U.S. Patent Application Serial No. 10/501,995
Response to Office Action Mailed November 17, 2005
Amendment Dated March 17, 2006

Amendments to the Drawings

Please replace the originally filed drawings with the Replacement Sheets attached in the Appendix. Fig. 1a and Fig. 1b have been amended to reflect the changes required by the Examiner. An annotated sheet of drawings showing these changes is attached.

Fig. 1a

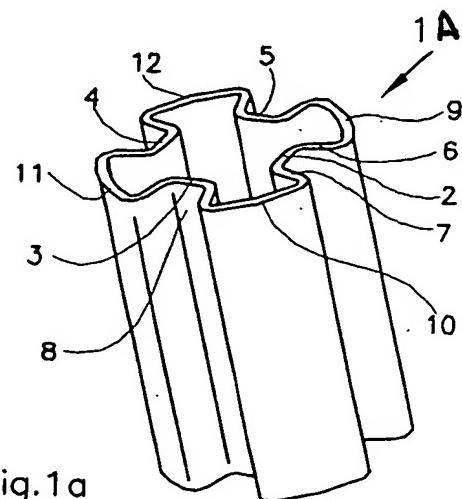
Specifically, Applicant has amended the labeling of certain figures in accordance with the Examiner's request. Applicant has also added new claims, each of the new claims containing one or more features commonly agreed to as not being taught or disclosed by the applied reference. Claims 1-6 and 10 have been cancelled without prejudice or disclaimer and new claims 11-21 have been added. Claims 7-9 have been withdrawn.
